ADDENDUM TO BID DOCUMENTS

Pleasanton Unified School District	ADDENDUM 01
	Project: CTE Workshop Modular Increment 2 Foothill High School Project (2021-22.06)
	Date: November 29, 2021

2 SECOND FLOOR PLAN
1/8" = 1'-0"

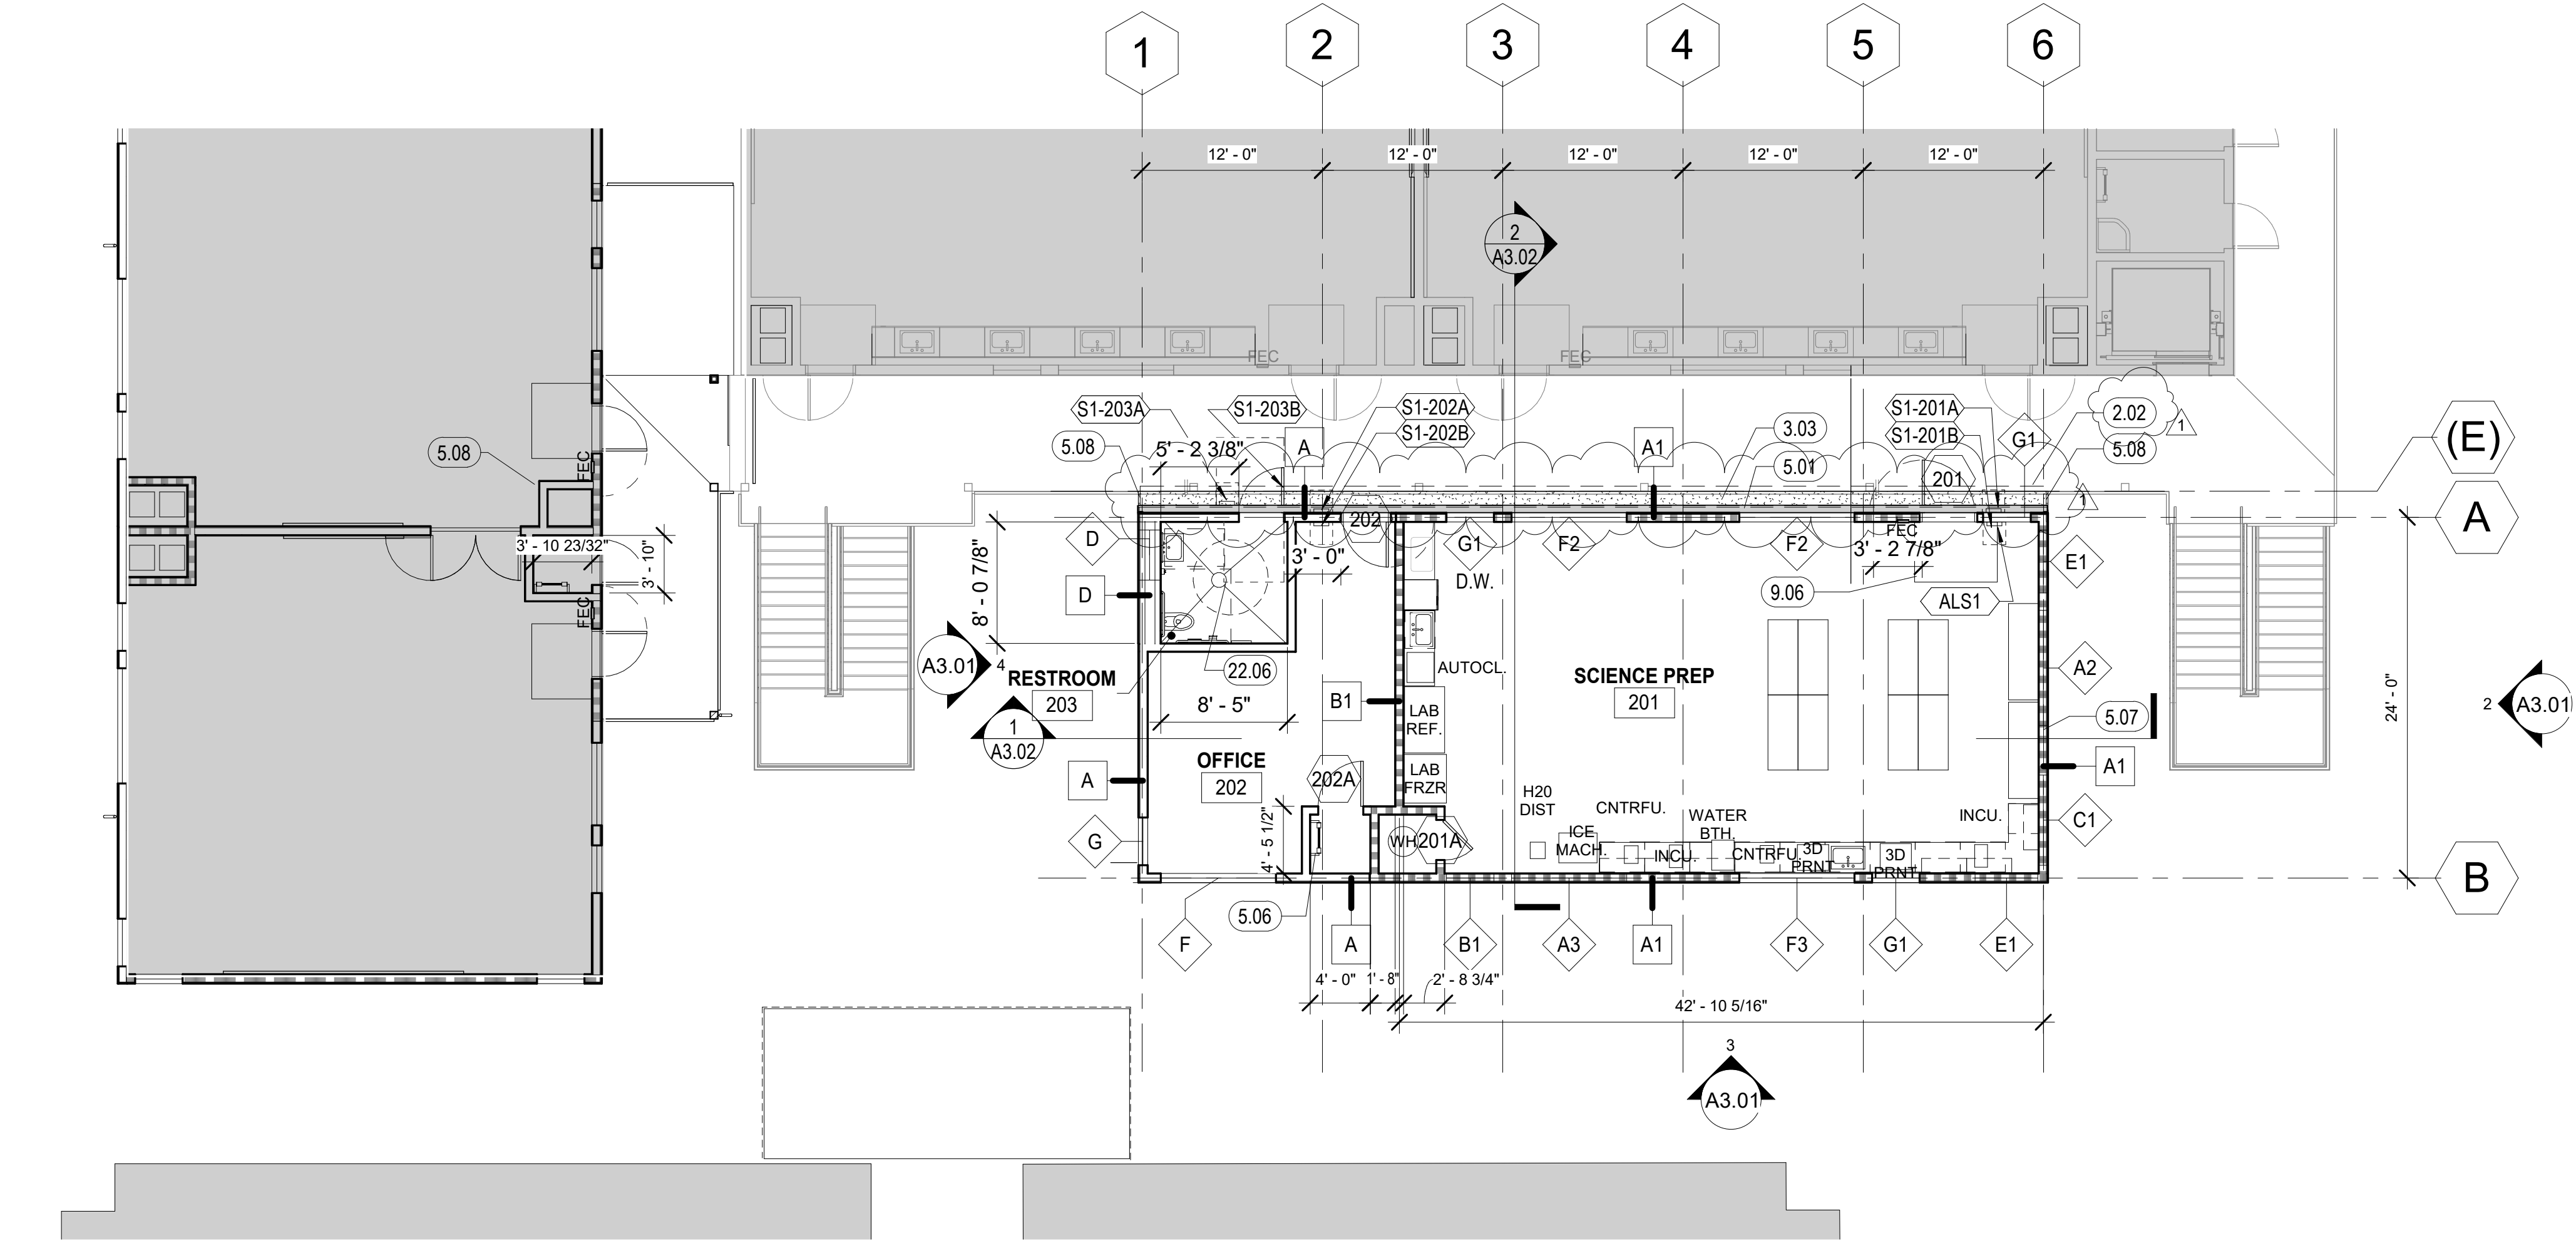
Add Sheet Note 2.02 "REMOVE (E) GUARDRAIL AND SALVAGE FOR REUSE AT WALKWAY EXTENSION", Add Sheet Note 2.02 to plan that calls out demolition location of guardrail.

Change Sheet Note 3.03 to "EXTENSION OF CONCRETE WALKWAY" This work will now be part of this Increment 2 scope of work.

Change Sheet Note 5.08 to "VERTICAL SEISMIC JOINT ALUM COVER AND GUARDRAIL EXTENSION FROM SALVAGED GUARDRAIL".
